Appendix K DEIR Comment Letters

Subject: Draft Environmental Impact Report for Harvard Westlake Parking Improvement Plan, Los Angeles County, (SCH # 2013041033)

Review of the Draft Environmental Impact Report (Draft EIR) for the Proposed Harvard-Westlake Parking Improvement Plan Project

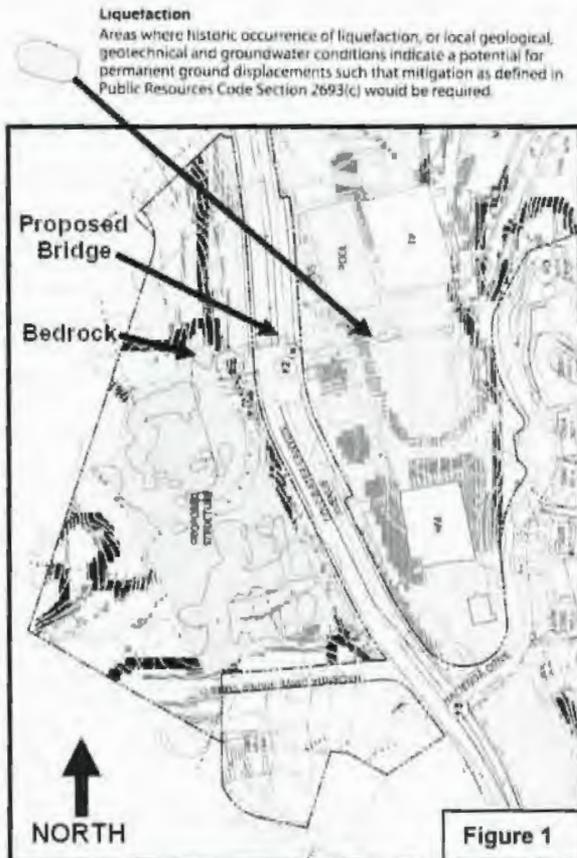
Retaining walls (to stabilize bedrock and alluvium/colluvium deposits) are proposed on the Development Site along the north, west and south sides of the Parking Structure, immediately adjacent to the structure. These walls would vary in height from approximately 20- to 87-feet high. Due to the topography of the Development Site, the retaining walls are necessary to protect the adjacent hillsides and to construct the Parking Structure.

Although there has been no geotechnical evaluation of the bridge provided, geologically the west side of the bridge would be founded in either thin alluvium/colluvium or bedrock, while the east side would very likely be founded in liquefaction-prone alluvium (Figure 1) based on published State Seismic Hazard Maps (CGS [formerly the CDMG], 1998) depending upon the depth of alluvium, which is presently unknown. The potentially significant difference in foundation properties could cause each side of the bridge to react differently during a moderate to large earthquake on any of the numerous earthquake faults delineated in the site region (GPI, 2010 and 2013; DEIR, 2013). Bedrock or shallow alluvium in the west would shake at a different frequency than deeper liquefaction prone alluvium on the east, potentially causing the bridge to fail onto Coldwater Canyon Avenue.

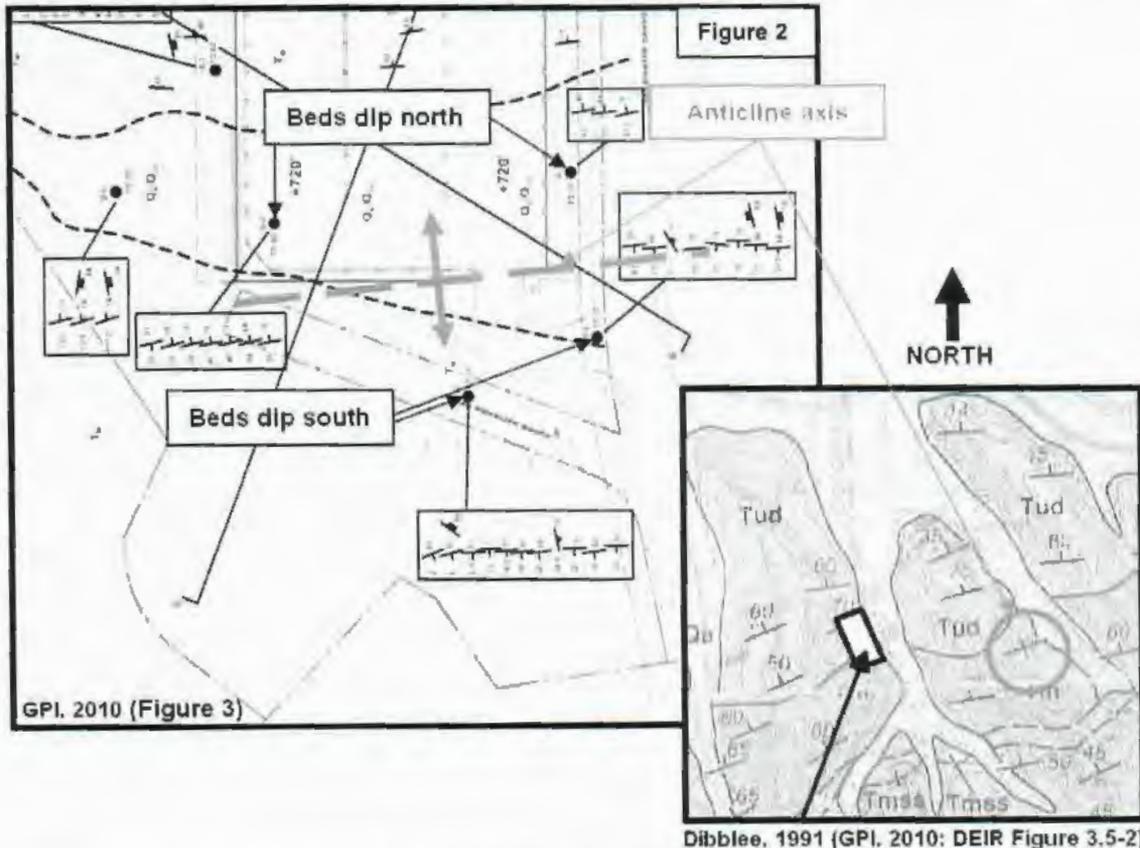
GPI presents the results of their down-hole logging of several bucket auger borings (their Appendix A, A-1 through A-10 Logs of Borings) and applies these data/results to their geologic cross-sections A-A', B-B', and C-C' (their Figures 4, 5, and 6). Unfortunately none of the three cross-sections were constructed in the most critical (highest) portions of the proposed cut slopes, thereby not analyzing the most potentially unstable areas. For example, cross-section B-B' shows a cut slope height of approximately 45-feet, while the slope 70-feet to the north is approximately 65-feet high and maybe as high as 87-feet. The same situation occurs for cross-section C-C', where the slope is much higher north of the section. For cross-section A-A' the subsurface conditions of A_F over T_M are very detailed, yet there is no citation for where this detailed information was obtained. This placement of cross-sections calls into question whether the associated slope stability calculations represent realistic depictions of the conditions that would face construction workers (regarding safety) and that would define long-term slope stability affecting the proposed project and neighboring properties.

Also, cross-sections C-C' and B-B' appear not to consider the potential for an anticlinal axis that may pass between borings B-10 and B-2 and between borings B-9 and B-7. The steeply dipping bedding shown south of the proposed cut slope (C-C' "Apparent Dip of bedding steepens w/depth") is shown as overturned, yet this is not how the information is recorded in the B-10 and B-9 boring logs or displayed on the Site Plan (geologic map Figure 3 strike and dip symbol insets). No overturned bedding is shown by Dibblee (1991). A more reasonable interpretation would appear to be an anticlinal axis located such that as bedding transitions from a southerly dip on the south to a northerly dip on the north, that just north of the axis bedding could well be out-of-slope along the south (north-facing) cut slope (Figure 2). Dibblee (1991) in fact shows the axis of an anticline just to the

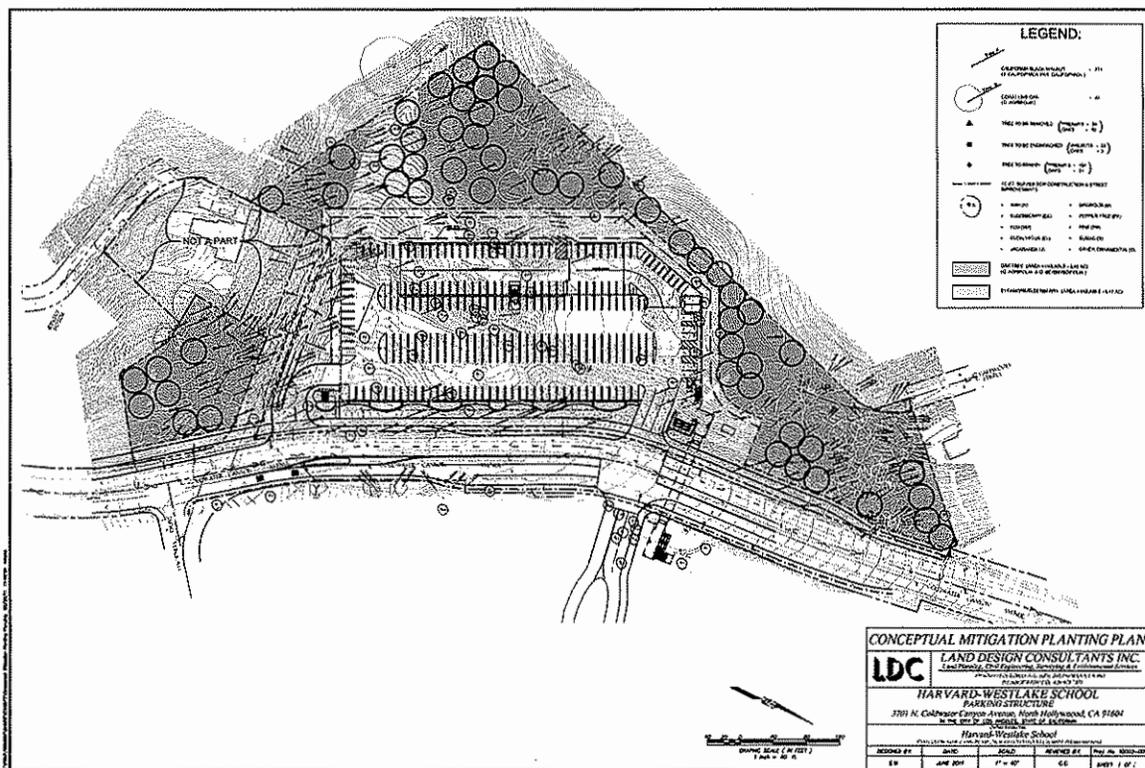
Figure 1. Project proponent’s conceptual mitigation planting plan with annotations (black circles) noting locations that could conceivably accommodate a mature Coast Live Oak or California Walnut with a 40-foot diameter canopy (54 locations). The DEIR proposes planting 516 trees in this area, which is far too dense and those “mitigation” trees would not survive to maturity.

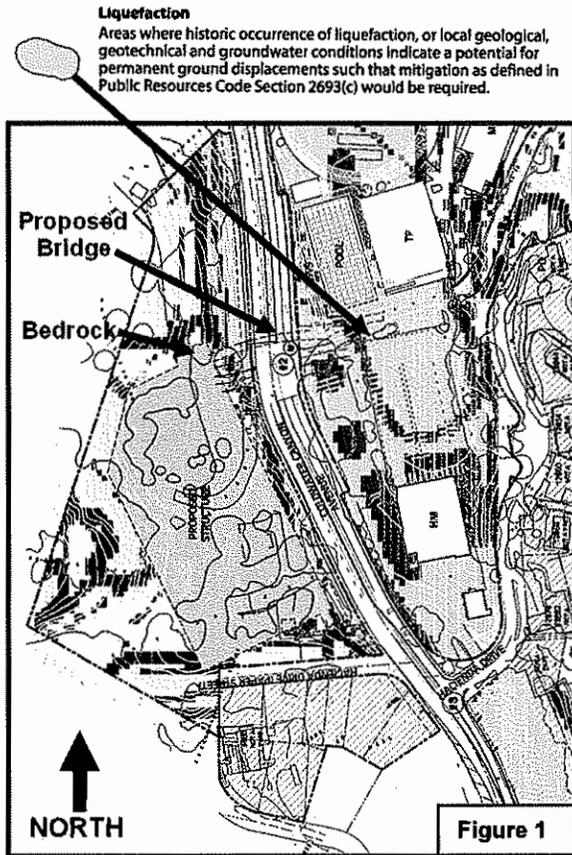
The Project Description describes a bridge structure crossing Coldwater Canyon connecting the main campus with the proposed parking structure. No geologic or geotechnical data and/or studies have been provided to assess and verify the feasibility of constructing such a bridge structure at this location. The bridge is not discussed in the geology and soils section of DEIR (2013) or the 2010 GPI report. The bridge is a very significant structure as defined in the Project Description section of the DEIR:

Although there has been no geotechnical evaluation of the bridge provided, geologically the west side of the bridge would be founded in either thin alluvium/colluvium or bedrock, while the east side would very likely be founded in liquefaction-prone alluvium (Figure 1) based on published State Seismic Hazard Maps (CGS [formerly the CDMG], 1998) depending upon the depth of alluvium, which is presently unknown. The potentially significant difference in foundation properties could cause each side of the bridge to react differently during a moderate to large earthquake on any of the numerous earthquake faults delineated in the site region (GPI, 2010 and 2013; DEIR, 2013). Bedrock or shallow alluvium in the west would shake at a different frequency than deeper liquefaction prone alluvium on the east, potentially causing the bridge to fail onto Coldwater Canyon Avenue.

D-193

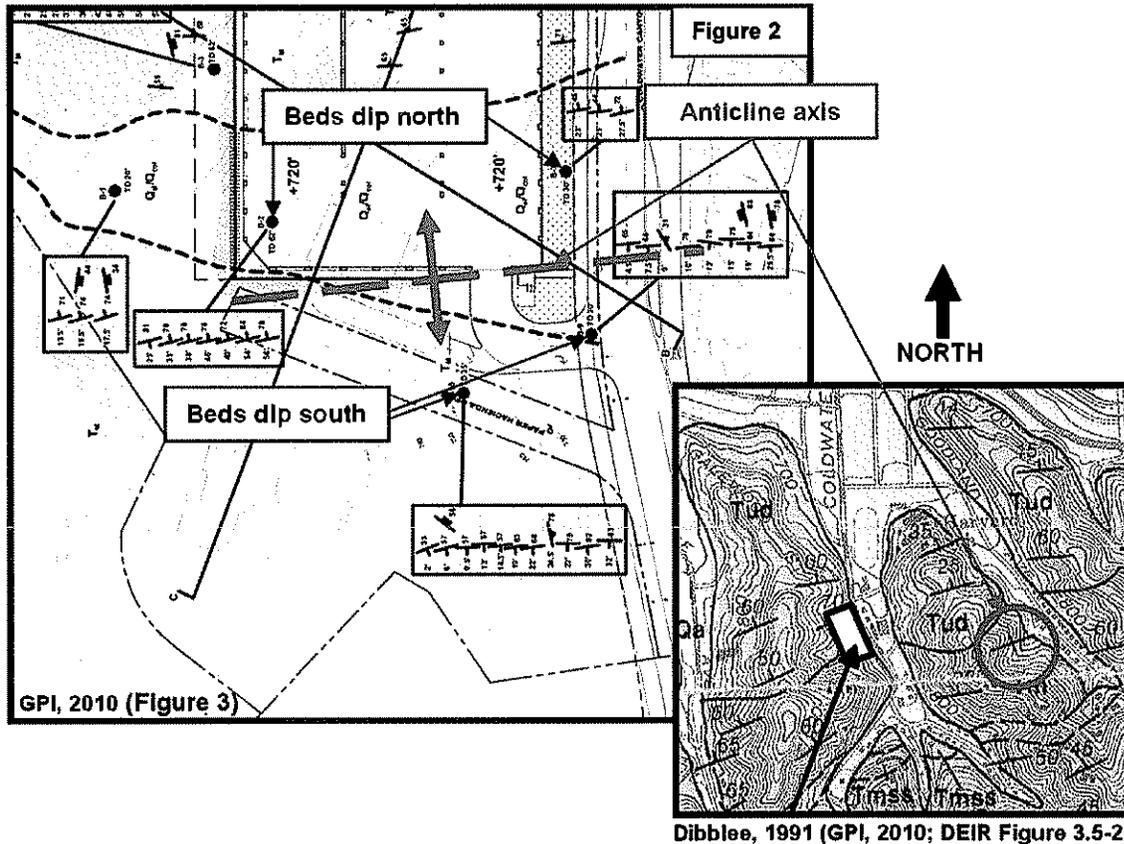
failure surfaces) with an out-of-slope component leaves unsettled the overall stability of these proposed high cut slopes. This unanalyzed condition would potentially create unstable slopes affecting construction safety and possibly longer term slope stability. Combined with the current cross-sections being in the less critical locations, this leaves open the question of the feasibility of the proposed cut slopes.

Also, cross-sections C-C' and B-B' appear not to consider the potential for an anticlinal axis that may pass between borings B-10 and B-2 and between borings B-9 and B-7. The steeply dipping bedding shown south of the proposed cut slope (C-C' "Apparent Dip of bedding steepens w/depth") is shown as overturned, yet this is not how the information is recorded in the B-10 and B-9 boring logs or displayed on the Site Plan (geologic map Figure 3 strike and dip symbol insets). No overturned bedding is shown by Dibblee (1991). A more reasonable interpretation would appear to be an anticlinal axis located such that as bedding transitions from a southerly dip on the south to a northerly dip on the north, that just north of the axis bedding could well be out-of-slope along the south (north-facing) cut slope (Figure 2). Dibblee (1991) in fact shows the axis of an anticline just to the
